## Industry/TSTF Standard Technical Specification Change Traveler

**AFW train operable when in service**

NUREGs Affected:  1430  1431  1432  1433  1434

AFW System  
 3.7.5  
 TSTF 245  
 REV 1

SR 3.7.5.1

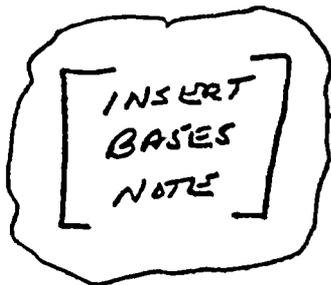
Add a note to SR 3.7.5.1 similar to the Note for RHR in SR 3.5.3.1, "An AFW train may be considered OPERABLE during alignment and operation for steam generator level control, if capable of being manually realigned to the AFW mode of operation."

2/5/98 - Revise Bases on page B3.7-30, delete last sentence of paragraph, add Insert Bases Note, Delete reviewer's Note on page B3.7-31. WOG only.

The SR is modified by a Note that states one or more AFW trains may be considered OPERABLE during alignment and operation for steam generator level control, if it is capable of being manually (i.e., remotely or locally, as appropriate) realigned to the AFW mode of operation, provided it is not otherwise inoperable. This exception allows the system to be out of its normal standby alignment and temporarily incapable of automatic initiation without declaring the train(s) inoperable. Since AFW may be used during startup, shutdown, hot standby operations, and hot shutdown operations for steam generator level control, and these manual operations are an accepted function of the AFW system, OPERABILITY (i.e., the intended safety function) continues to be maintained.
